Location:	6501 Shattuck Avenue- See map on reverse
Assessor's Parcel Number:	016 142801102
Proposal:	Two Appeals of the Zoning Manager's Approvals: 1) to construct a 4-story mixed-use building with commercial space and parking on the ground floor and 18 residential units above; and 2) for two additional required permits for a Multifamily Dwelling Residential Facility and more than 20% of the required group open space on the roof which were not included on the previous public notice or original Decision Letter.
Applicant:	Moshe Dinar (510)759-2133
Owner:	Bruder, LLC
Appellant:	Appellant 1) Chris Hall Appellant 2) Caitlin Stuart
Case File Number:	APL19003 and APL20010
Original Case File Number:	CDV10185
Planning Permits Required:	Interim Conditional Use Permit for a density of 18 residential units where the General Plan allows for 31 units and the zoning only allows for 5 units; Minor Conditional Use Permit for a Multifamily Dwelling Residential Facility and parking to be setback less than 75 feet from the front property line, Regular Design Review for new construction; and Minor Variances to allow a 13-foot high garage podium structure to project 7 feet into the required 15-foot rea

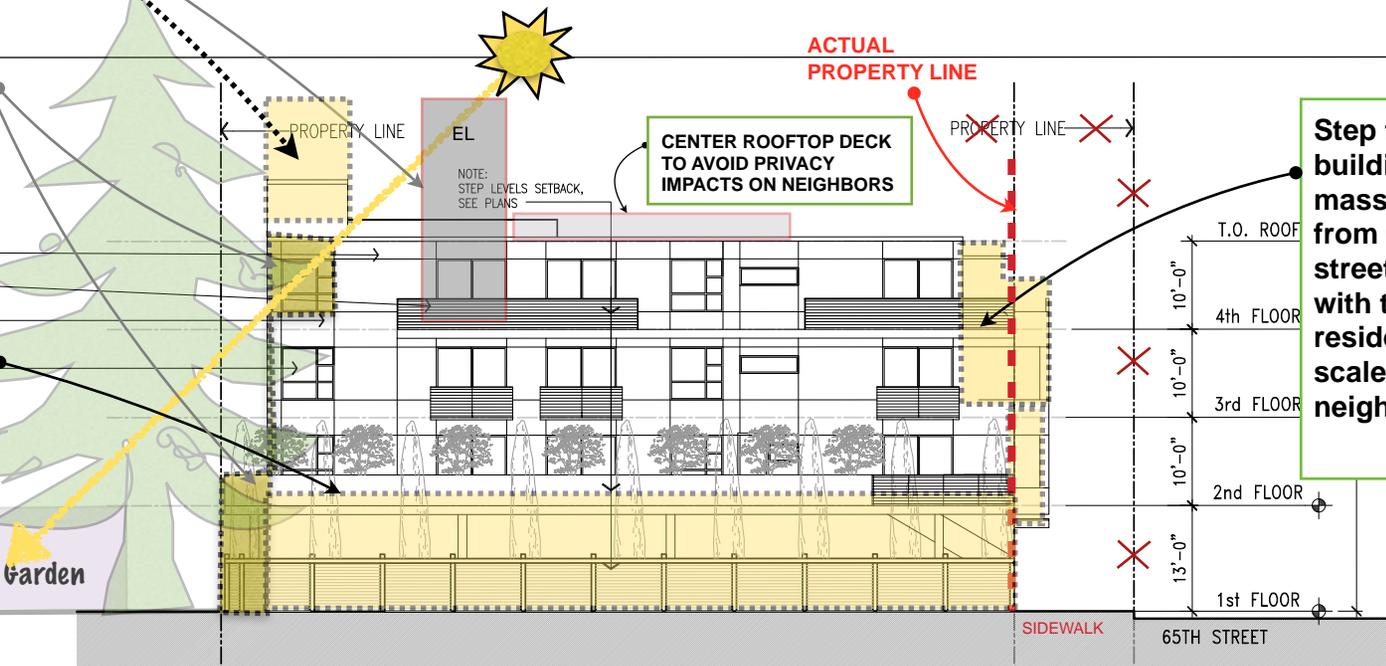
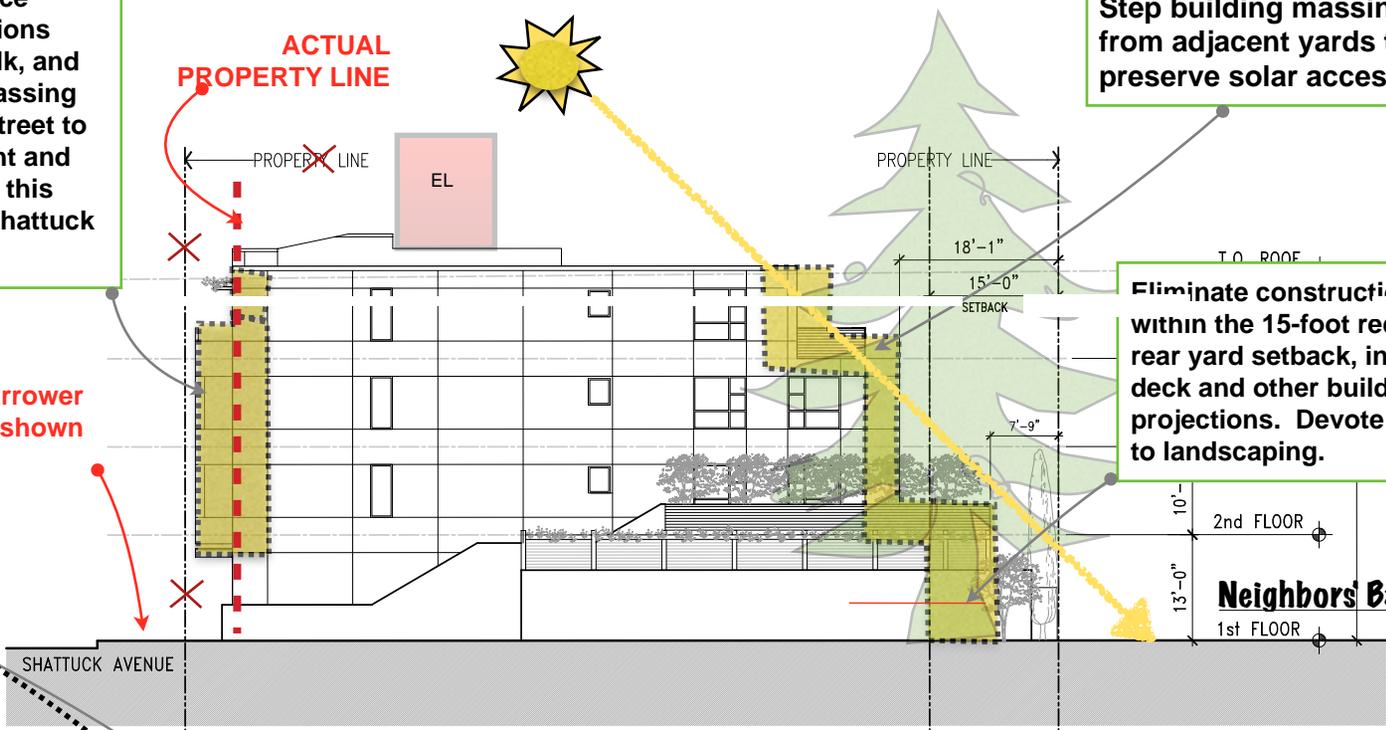
Step building massing away from north side property line and eliminate open stairs and elevated walkways directly on the property line

Relocate the group open space to the roof, and use parking lifts to eliminate paving in the rear yard setback. Dedicate the space to landscaping and at-grade open space
